February 22, 2018

Excelsior Mining, February 6, 2018

Technical Memorandum

Review of Underground Injection Control ~~Aquifer Project Permit and Application~~ Gunnison Copper Project

Figure 1514: Figure 33 from Attachment A-2Appendix I showing groundwater elevation contours, residuals at observation wells, and residual statistics.

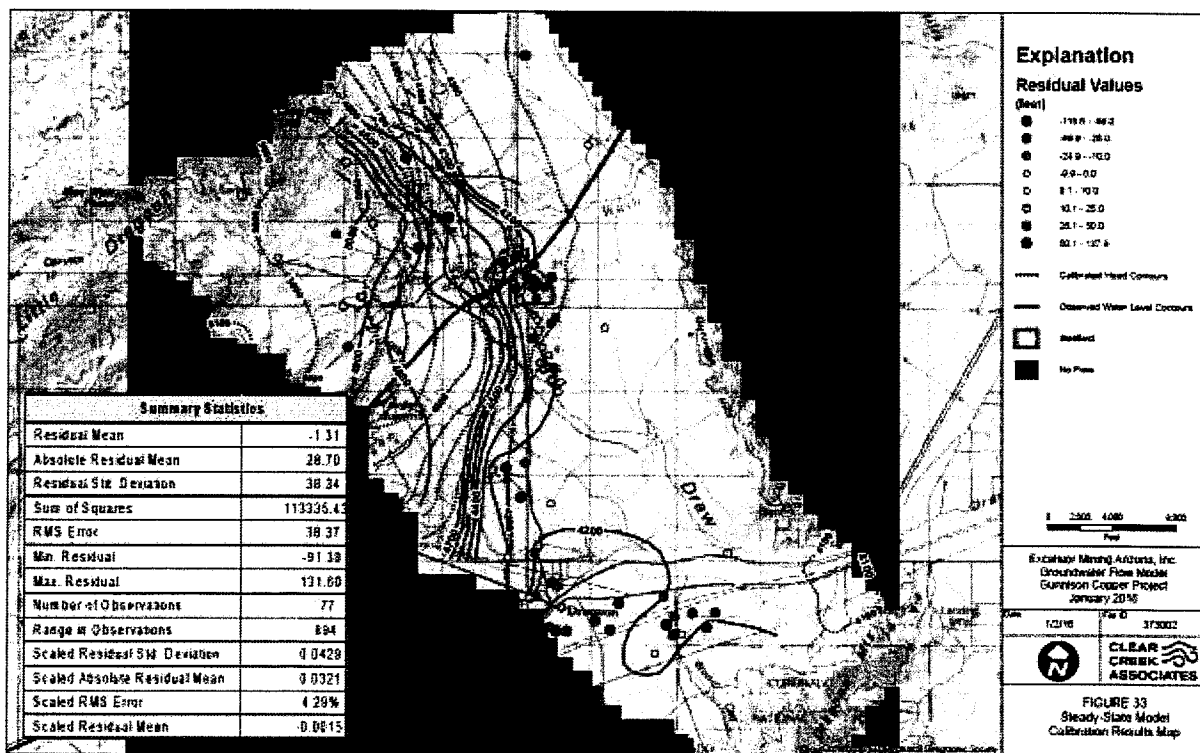
Vertical K equals horizontal K for all bedrock, so there is no reference to deep groundwater flow. There is no discussion of vertical circulation as part of the conceptual model, meaning the

modelers had no expected natural vertical circulation of groundwater flow. It is likely that the numerical modeling allows an unrealistic amount of water to flow at depth through the domain because of vertical K equaling horizontal K, especially at depths below layer 1. Attachment A-2 (Appendix A) does not provide water balance data, either for the entire model or for individual layers, as is customary for the presentation of groundwater model results (Anderson and Woessner 1992). This limits the ability of the reviewer to assess how realistic is the simulated groundwater flow.

- The reviewer should have noted that, in general, modeled permeability decreases with depth which would have the effect of limiting deep groundwater flow. This is readily apparent in the area of basin fill to the east of the site where lower model layers (layers 4-7) have permeabilities consistent with bedrock overlain with higher permeability basin fill.
- As noted previously, the water balance for this site is very simple – groundwater recharge in, groundwater underflow out. Clear Creek provided a detailed summary of the recharge value (UIC application, Section 2.5.2, Table 4, Appendix A-2), therefore the water balance should be obvious.

Figure 1918: Figure 46 from Attachment A-2Appendix I showing the progression of mining, in blue, and simulated hydraulic control wells.

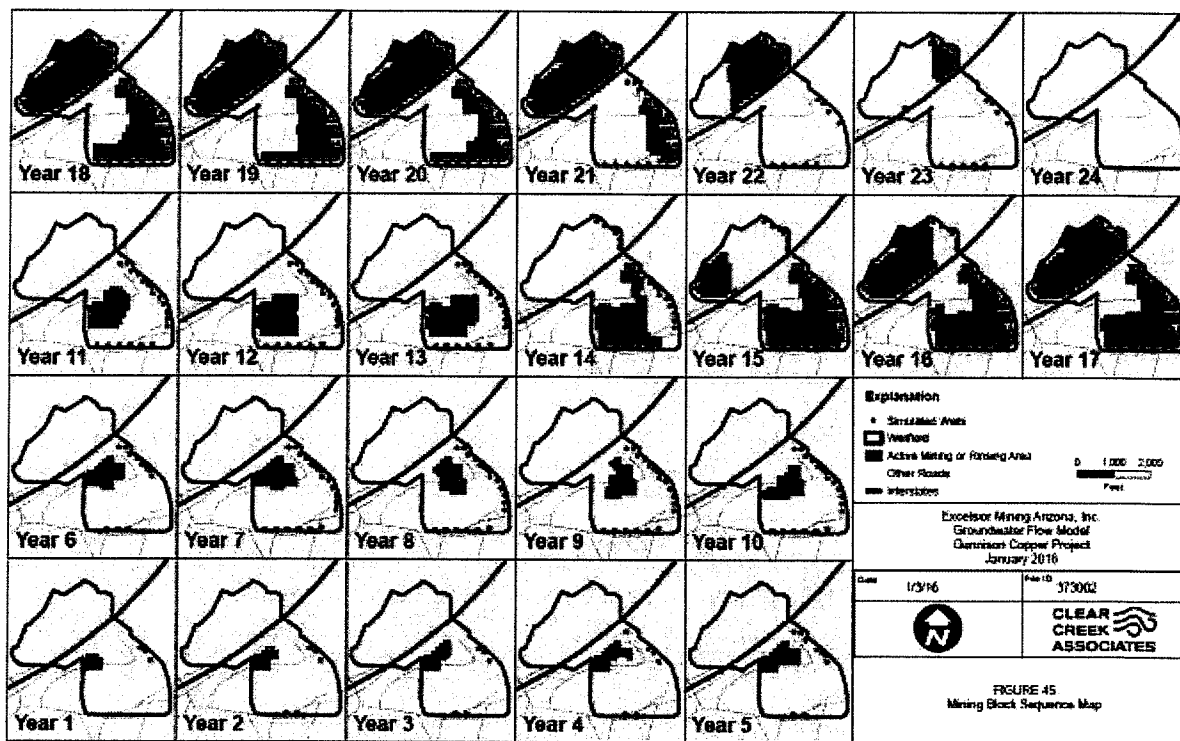
The model simulates pumping the hydraulic control wells that surround the well field, but does not simulate the 5-spot injection/collection regime within the well field (Figure 1918). The hydraulic control well pumping was imposed on the steady state flow simulated in the calibration. Simulations ran for 23 years, simulating each year as a new stress as new blocks of injection/collection wells come on line (Figure 1918). Pumping rates extend to only about 190 gpm total. Only hydraulic collection wells downgradient from operating injection/collection wells were operated during any given year. As may be seen from the annual drawdown maps (Attachment A-2Appendix 4, Figures 48 – 56), drawdown centers on the hydraulic collection wells and the model simulated no groundwater level changes near the area being mined.

Untrue. While the largest drawdowns are centered at the HC wells in Year 10, there is still 19 feet of drawdown in Mine Block 1. This is based on zero net withdrawal within the wellfield (i.e. equal injection and recovery within mining blocks) and all net withdrawal occurring at the HC wells.

Figure 2019: Figure 47 from Attachment A-2Appendix I showing the location and times that contaminant particles are released for simulation.

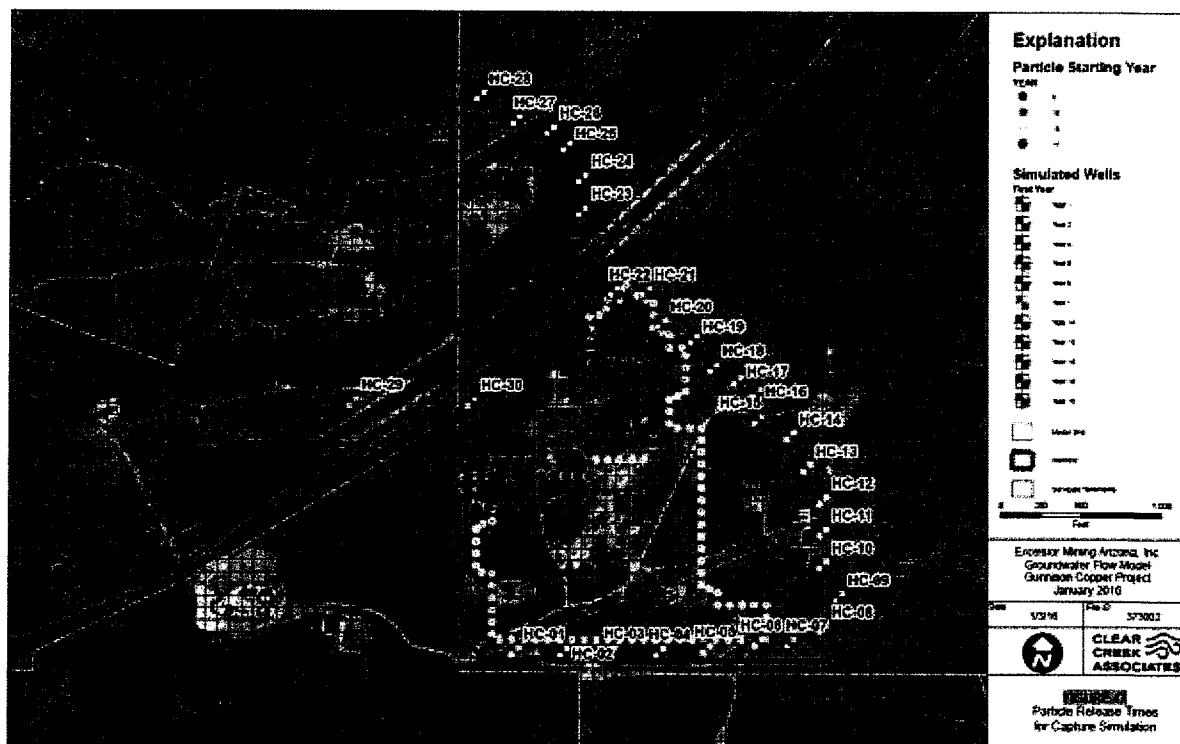
Particle track modeling shows that released contaminants would not escape the well field, but the modeling provides little confidence in the results. The particles follow the simulated flow paths, which are average flow paths that do not account for preferential flow paths through fracture zones.

- The Gunnison groundwater model is based on the detailed geological and structural models, which capture the larger faults and hence the preferential flow paths. This means any preferential flow paths are incorporated in the hydrological model. Particles were used as a general means to assess capture from groundwater flowing away from mine blocks at various times during mining. Average flow paths are appropriate for the containment assessment and incorporate structural heterogeneity.

Figure 2120: Figure 60 from Attachment A-2Appendix I showing the simulated groundwater contours and groundwater velocity vectors for model layer 3, year 21, the end of Stage 3 mining.

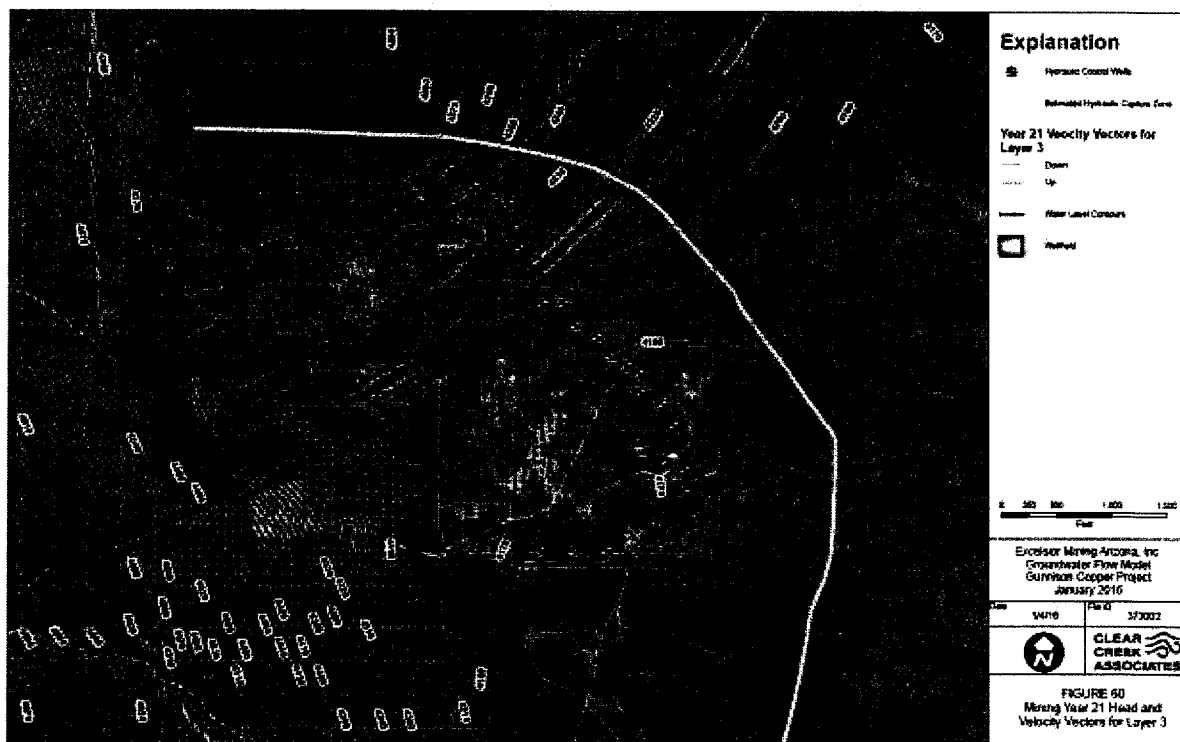
Not all areas within a drawdown cone are areas in which the groundwater flow is toward the middle of the cone. If the baseline groundwater contours dip steeply in one direction, a drawdown may just be a change in slope and the flow may still be away from the cone. Figure

2120 shows groundwater velocity vectors (arrows showing direction with the length of the arrow proportional to the speed of groundwater flow) and the groundwater contours (not drawdown) for year 21 (not accounting for injection/collection wells). On the north, west, and south, the groundwater contours naturally slope steeply toward the well field, but in the east and southeast the contours define a relatively flat surface. The surface is so flat that small changes would could cause directional changes in the velocity vectors. The contours in Figure 2120 are based on the average head for a specific cell. There is a 4170 contour around the southeast corner of the wellfield delineates a trough in the contours meaning that simulated flow is to the center of the trough. Based on the estimated capture zone line, the yellow line on Figure 2120 which shows the position of the groundwater divide, the water level is relatively flat throughout the southeast quarter of the wellfield. The mound in the water table represented by the capture zone line is only a few feet higher than the water table in the southeast corner of the project. The pressure at different levels in the groundwater, from the water table surface to a point below the well field, could easily vary from that estimated by consideration only of the water table due to different transmissivity flow paths. Contaminants could escape from the hydraulic control through preferential flow paths through the mapped divide because the average heads in the model cells may not represent actual heads in the fracture zones.
